ADDENDUM NO. 3

September 28, 2023

Whiteland Community High School Phase 1
300 E. Main Street
Whiteland, IN 46184

This Addendum consists of Pages ADD 3-1 through ADD 3-2, Specification Section 00 31 00 – Indiana Bid Form, Specification Section 01 21 00 Allowances, and Specification Section 01 23 00 – Alternates, Architects Addendum No. 3, consisting of 11 pages, Specification Section 03 37 00 Stained and Sealed Concrete Floors, Crossroads Engineers Narrative, 301, 302, 400, 500, 501, 1000, LS001, LS002, LS002, L601, S102AGH, A503, A504, A505, A731, Primary Engineering Narrative, P002, P100M, P101AGH, P101M, P403, P501, P504, E201M, E601, E701, E705, Design27 Narrative.

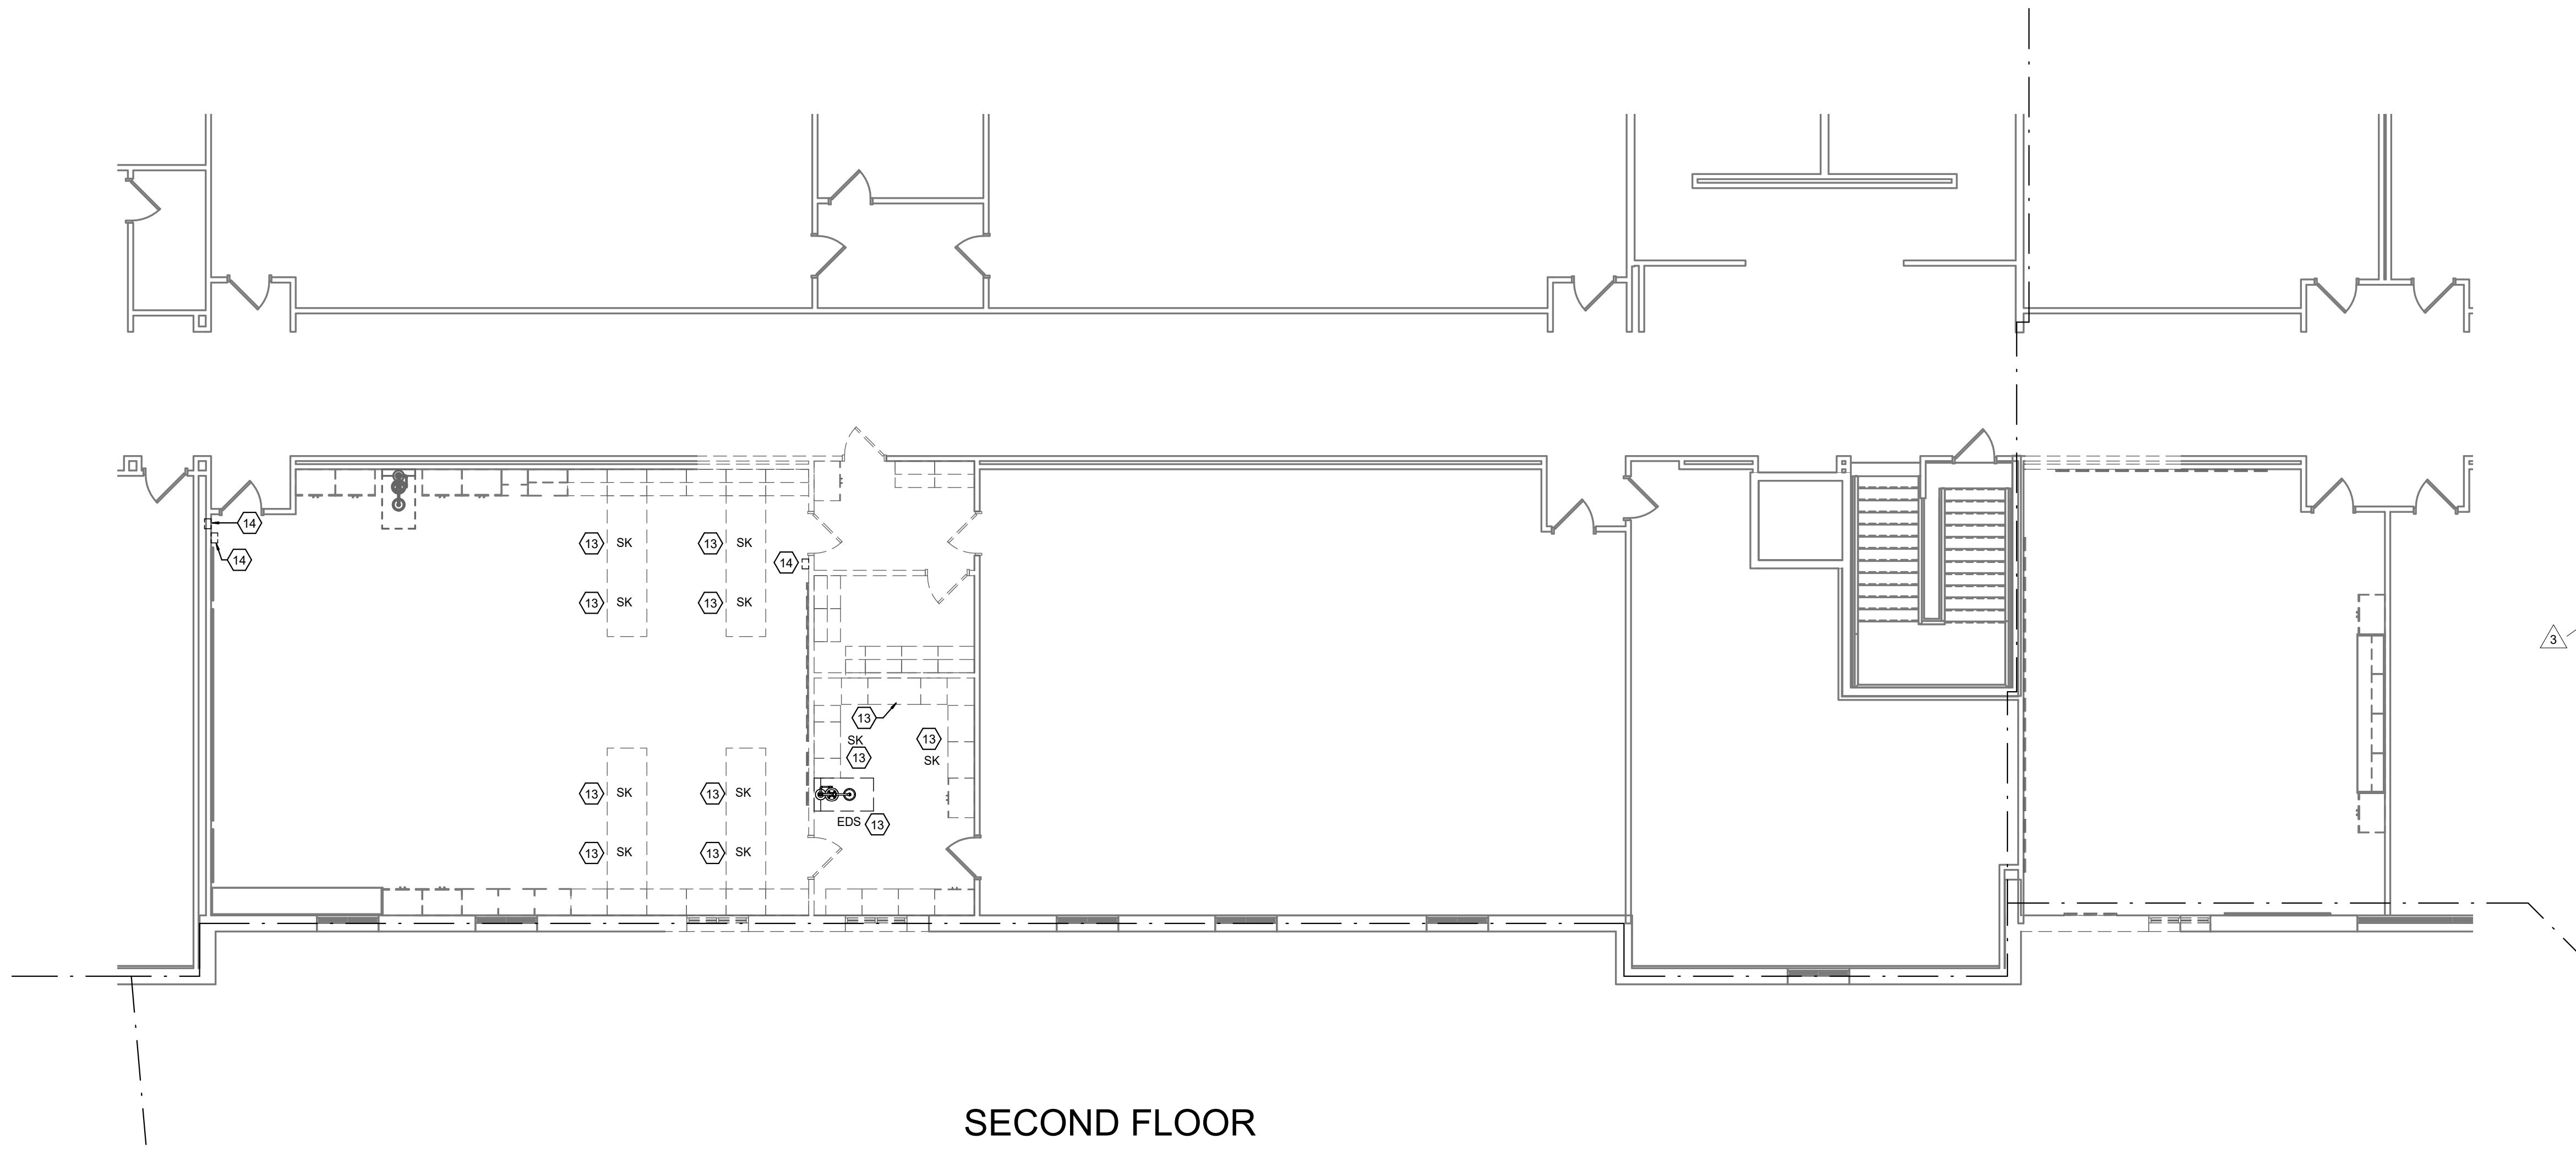
- A. Revised CT-2, CTP-1, & CTP-2 on riser diagram. Refer to supplemental information drawing E601.
